## Comments on “Development of Cross-Polar Orientation-Insensitive Chipless RFID Tags”

O. Rance, N. Barbot, E. Perret

O. Rance, N. Barbot, E. Perret. Comments on “Development of Cross-Polar Orientation-Insensitive Chipless RFID Tags”. *IEEE Transactions on Antennas and Propagation*, 2022, 70 (5), pp.3922-3923. 10.1109/TAP.2021.3133661 . hal-04047186

Fig. 1. Angular coverage of the individual dipoles and of the total unit cell. This figure should be compared with [1, Fig. 3] which uses scalar summation.

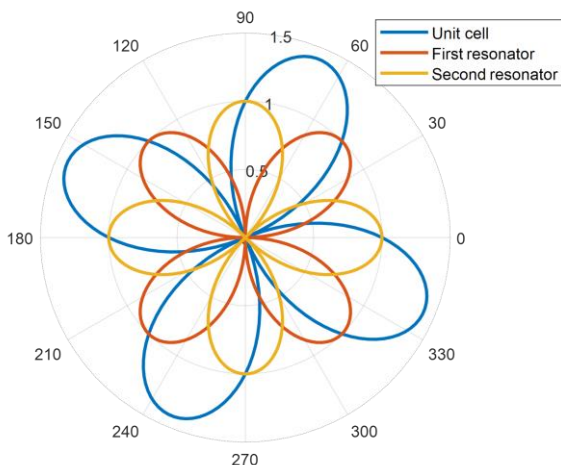
The methodology introduced by the authors to design cross-polar orientation-insensitive chipless tags is illustrated in [1, Fig. 3]. Two dipoles type scatterers oriented respectively at  $0^\circ$  ( $\mathbf{S}_1$ ) and  $45^\circ$  ( $\mathbf{S}_2$ ) are combined in order to improve the angular coverage of the total unit cell. The scattering matrix of the total target is given using superposition principle by:

$$\mathbf{S}(0) = \mathbf{S}_1(0) + \mathbf{S}_2(0) = A \cdot \begin{bmatrix} 1 & 0 \\ 0 & 0 \end{bmatrix} + A/2 \cdot \begin{bmatrix} 1 & 1 \\ 1 & 1 \end{bmatrix} \quad (4)$$

Using (3), this gives:

$$S_{vh}(\theta) = A/\sqrt{2} \cdot \cos(2\theta + \pi/4) \quad (5)$$

which appears to be zero for  $\theta = 22.5^\circ$  [90°]. The graphical representation of  $S_{vh}(\theta)$  normalized by  $A$  has been plotted in Fig. 1 for comparison with [1, Fig. 3]. The curves are identical for the first and the second resonators but the unit cell exhibits four nulls contrary to the scalar summation presented in [1]. Therefore, the unit cell shows no improvement in terms of angular coverage compared to the individual dipoles.
